June 2021  
 FL884 (D21R6)  
 NHTSA #21V-256 (Non-School Bus)  
 NHTSA #21V-255 (School Bus)  
 NHSTA #21E-029  
 Transport Canada #2021-219

**Subject: DETROIT™ Tie Rod & Steer Arm Bolt Replacement**

**Models Affected: DETROIT™ Model 2 and Model 3 Steer Axles**

### Subject: DETROIT™ Tie Rod & Steering Arm Bolt Replacement

**Fig. 1, Front Axle Components, Integral Steering Gear (driver side shown)**

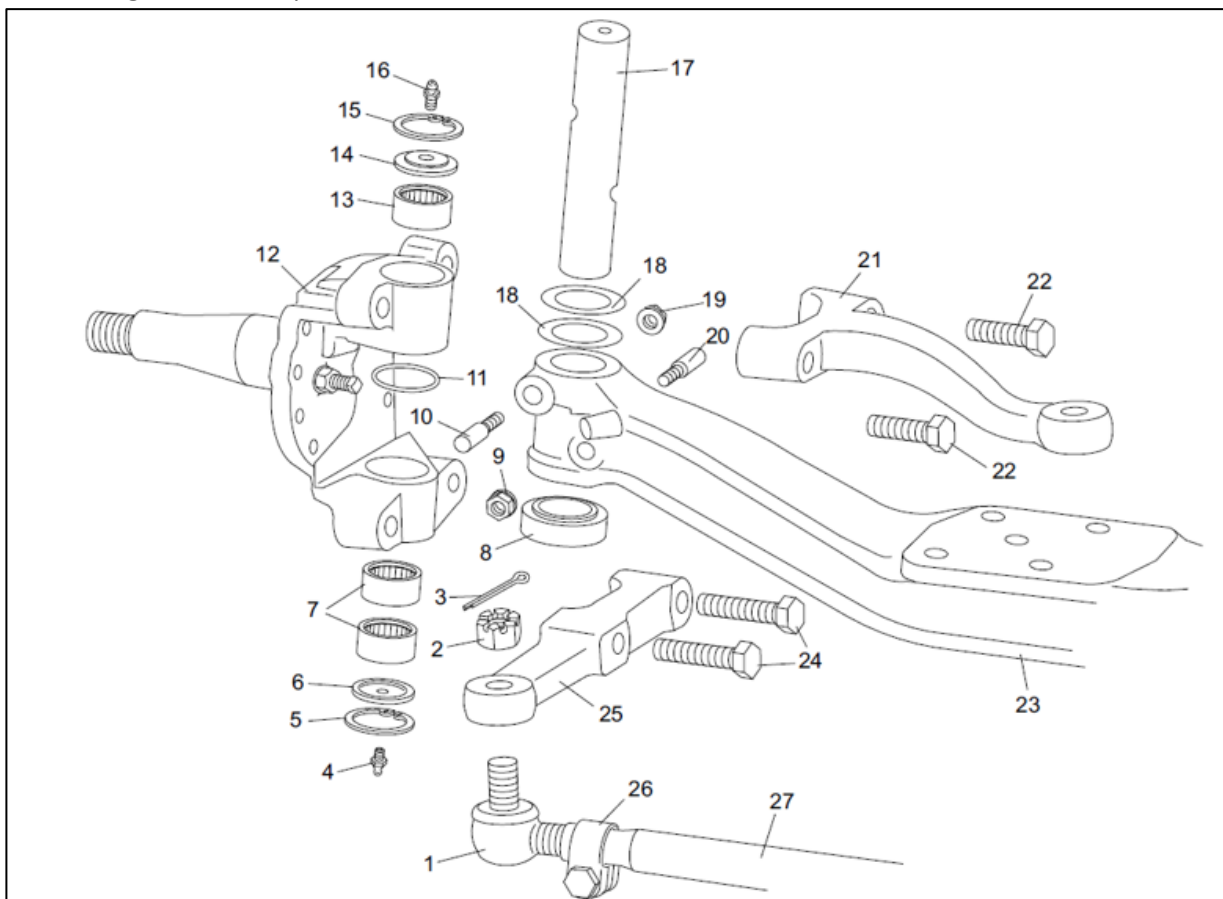
On certain Detroit Model 2 and 3 steer axles, the tie rod arm and steering arm bolts used to assemble front axle assemblies have a lengthwise “seam” defect which increases stress concentration, potentially leading to bolt failure or loss of pre-load.

Refer to **Fig. 1** for this repair.

**Only one bolt must be replaced at a time. If both tie-rod arm bolts, or both steering arm bolts are removed at the same time, a full truck alignment is required to be performed, which is not covered in this recall.**

8. At the passenger side, replace one tie-rod arm bolt as follows.
  - 8.1. Remove and discard the bolt.
  - 8.2. Clean the threaded hole from which the bolt was removed, and remove all oil and debris.

- 8.3. Clean a new bolt, remove any oil, and dry it completely.
  - 8.4. Apply Loctite® 277 to the bolt threads.
  - 8.5. Install the bolt on the steering knuckle. Tighten bolt to 425 lbf.ft (575 N.m).

9. Replace the other passenger side tie-rod arm bolt. Refer to substeps in step 8.
10. Turn the steering wheel to the left full-lock position.
11. At the driver's side, replace one tie-rod arm bolt. Refer to substeps in step 8.

12. Replace the other driver's side tie-rod arm bolt. Refer to substeps in step 8.
13. Replace one steering arm bolt. Refer to substeps in step 8.
14. Replace the other steering arm bolt. Refer to substeps in step 8.
